HISTORIC AND DESIGN REVIEW COMMISSION

HDRC CASE NO: 2015-353
ADDRESS: 431 KING WILLIAM
LEGAL DESCRIPTION: NCB 745 BLK 4 LOT E IRRG 193 FT OF 8 & E IRRG 223.46 FT OF 9
ZONING: RM4 H HE RIO-4
CITY COUNCIL DIST.: 1
DISTRICT: King William Historic District
LANDMARK: Steves, Edward, Jr House
APPLICANT: Nathan Perez/Ford, Powell & Carson Architects
OWNER: Caroline Forgason
TYPE OF WORK: Exterior modifications
REQUEST:

The applicant is requesting a Certificate of Appropriateness for approval to remove two windows and two doors in a 1985 addition as well as perform exterior modifications regarding siding.

1 SECOND FLOOR DEMO PLAN

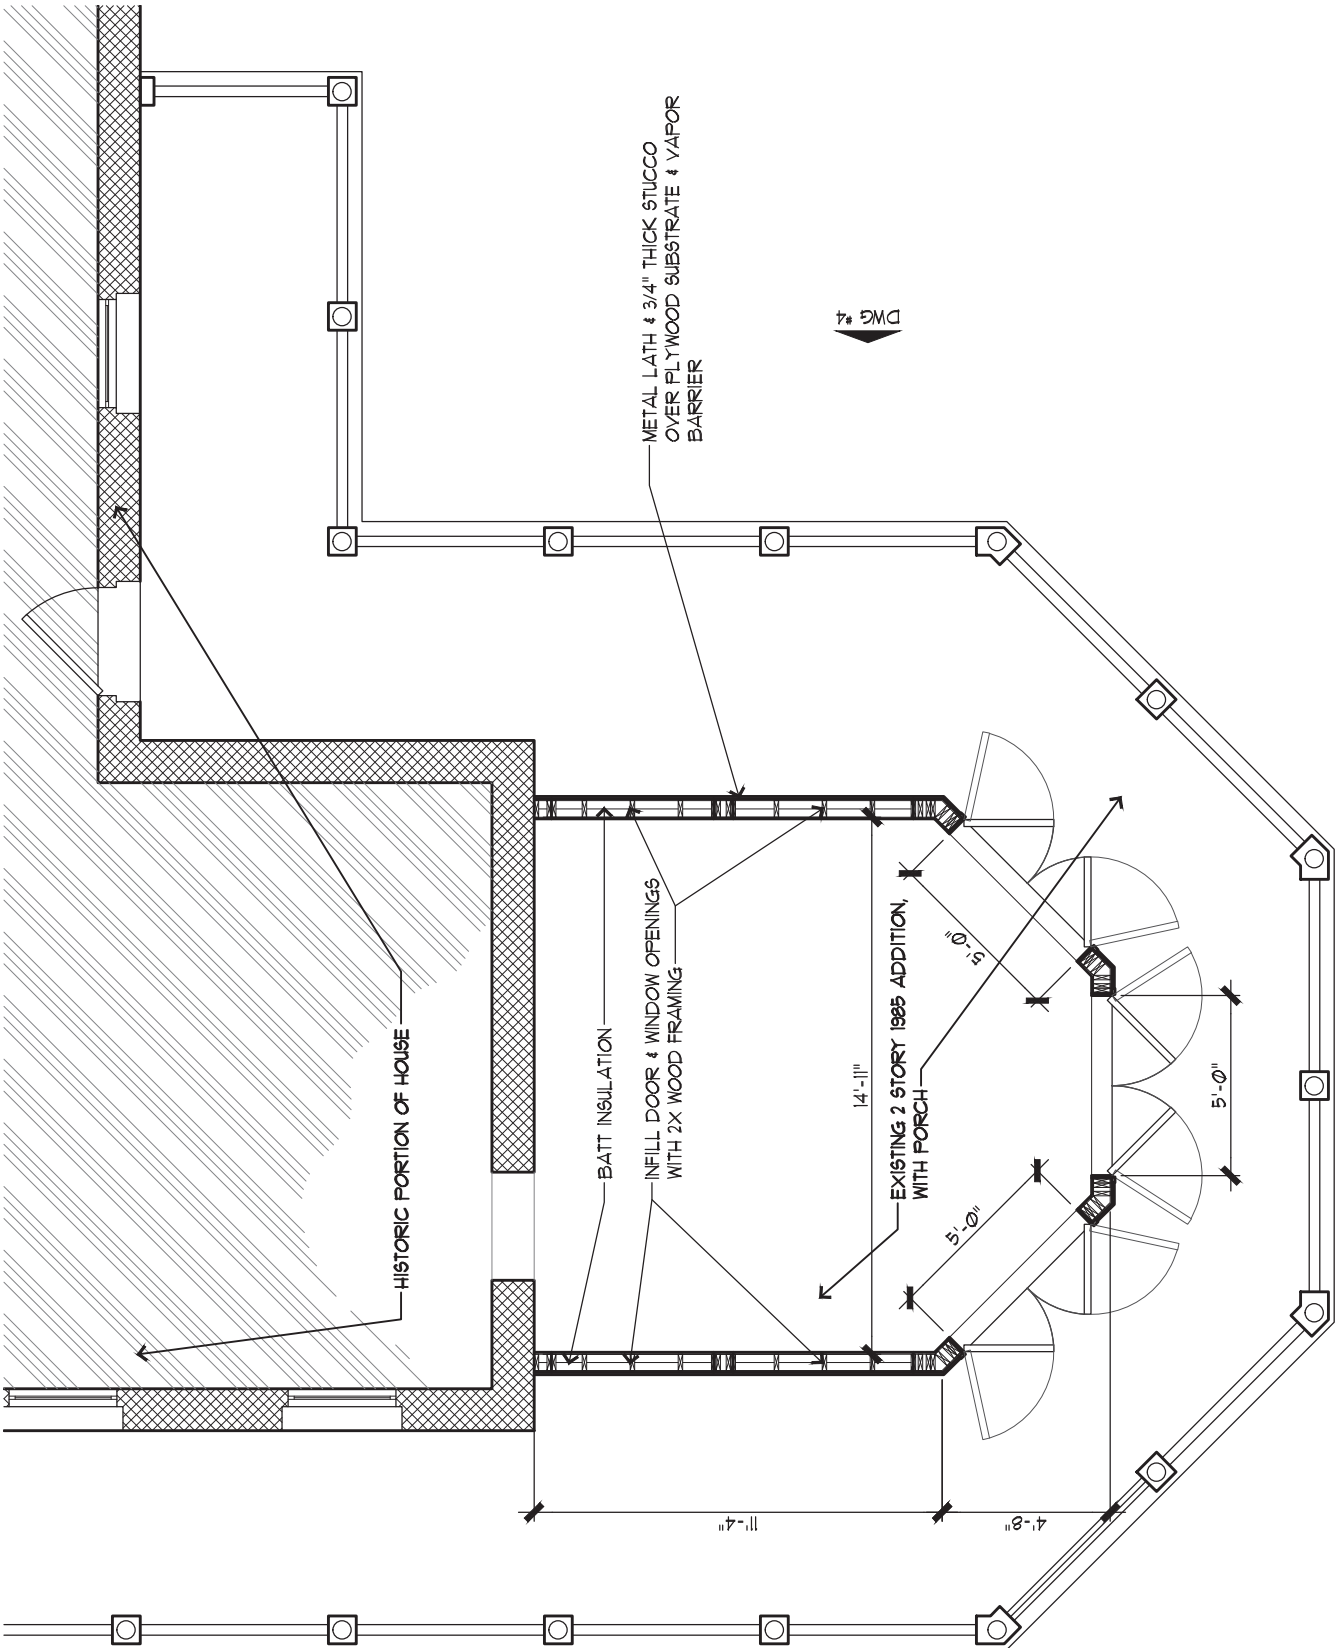
- a. The applicant has proposed to remove two large windows and two glass double doors on both the east and west facades of a second floor space that was added to the primary historic structure in 1985. The applicant has proposed

to remove these window and door openings to minimize the amount of solar heat gain during the afternoon hours. The applicant has noted that the window and door openings on the north façade are to remain. Given the non historic status of the proposed addition, staff finds the removal of the existing windows and door appropriate.

NORTH ELEVATION

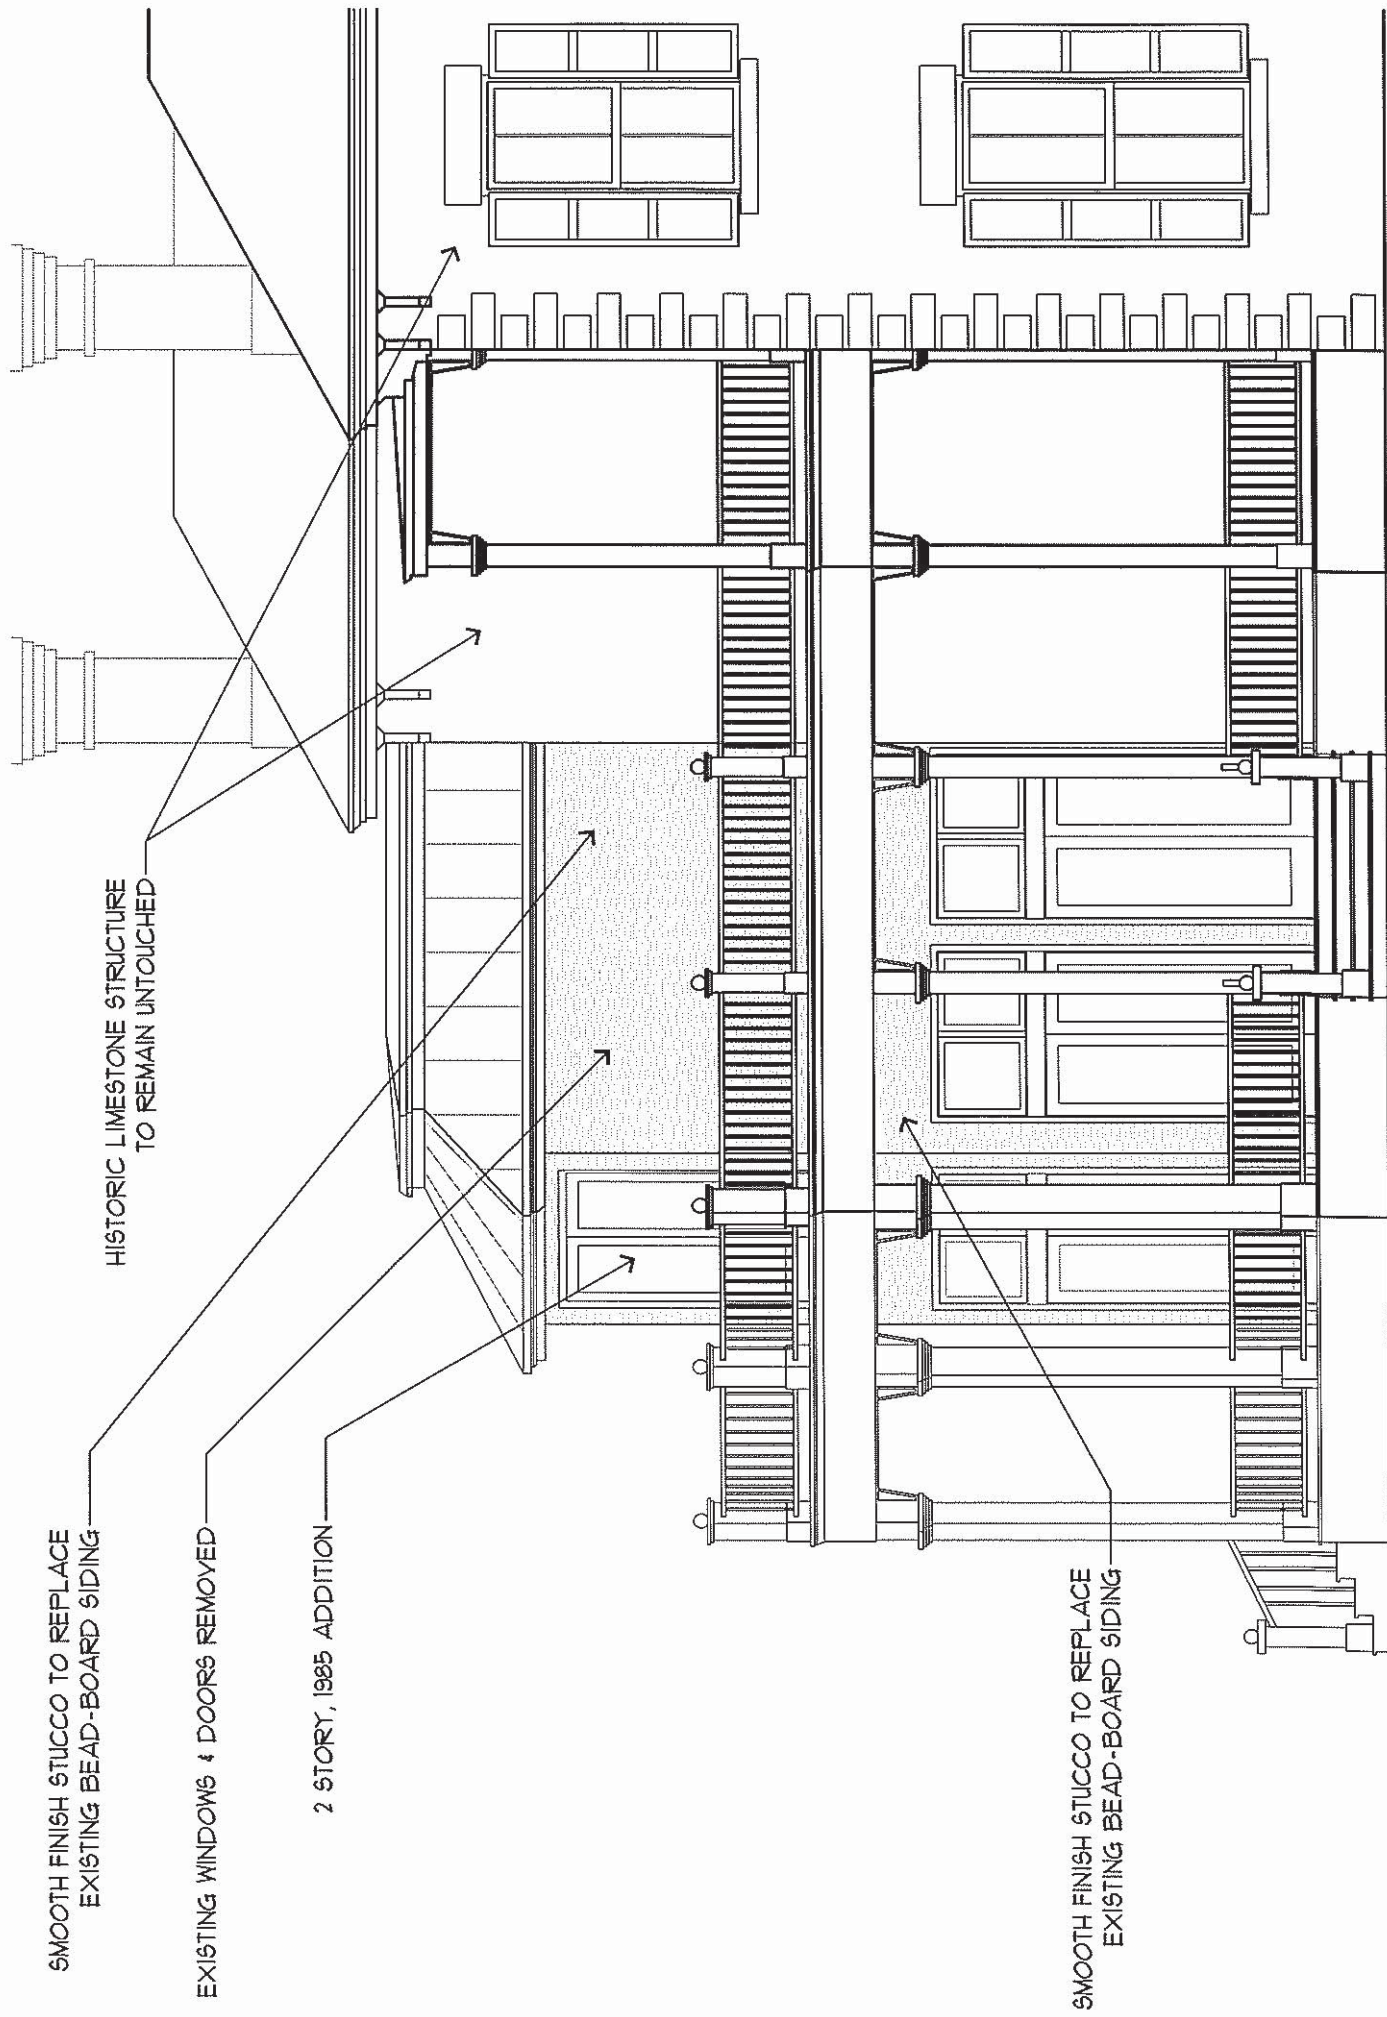
EXISTING BEAD-BOARD SIDING TO BE REPLACED
WITH SMOOTH FINISHED STUCCO
TO MATCH CARRIAGE HOUSE/GARAGE

WEST ELEVATION

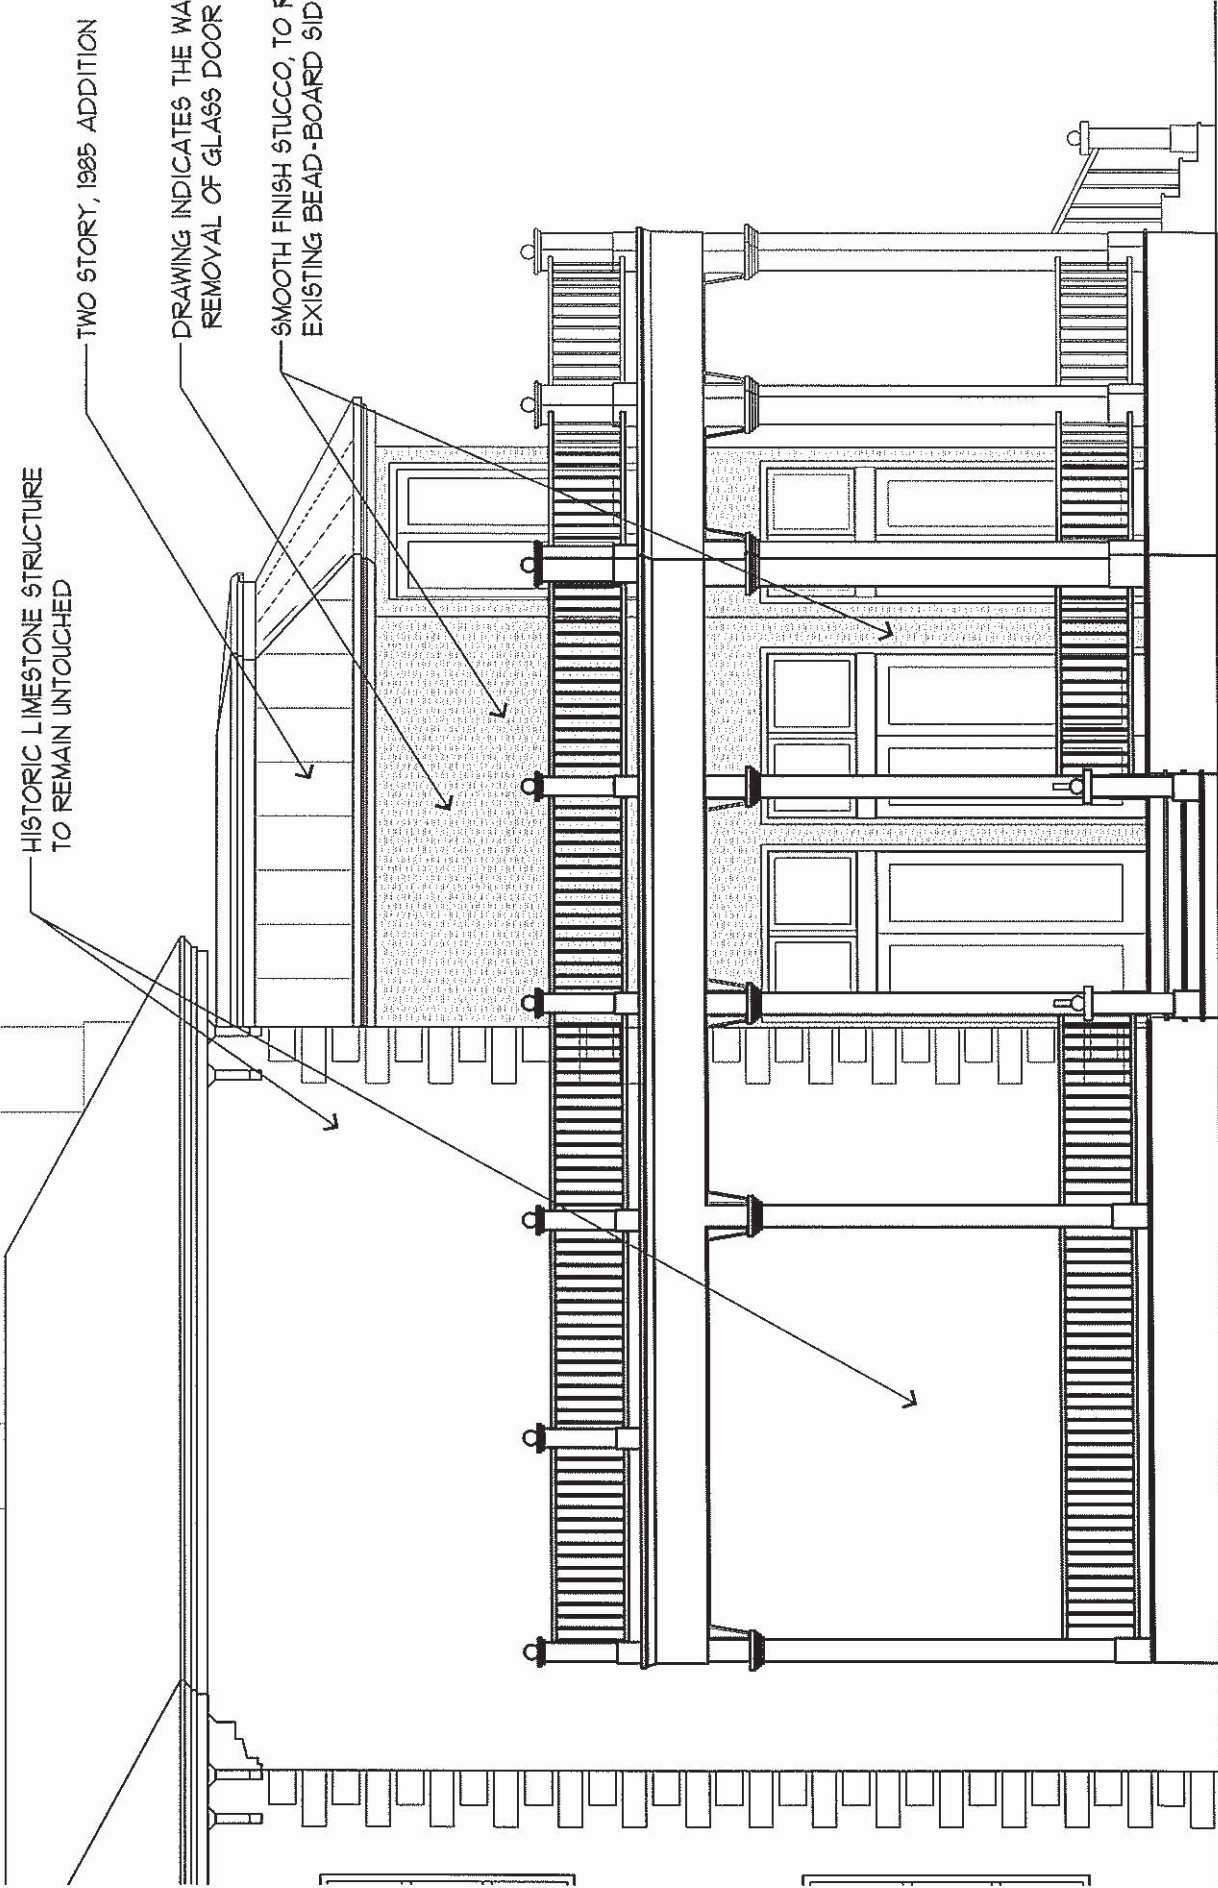
SMOOTH FINISH STUCCO TO REPLACE
EXISTING BEAD-BOARD SIDING

EXISTING WINDOWS & DOORS REMOVED

SMOOTH FINISH STUCCO TO REPLACE
EXISTING BEAD-BOARD SIDING
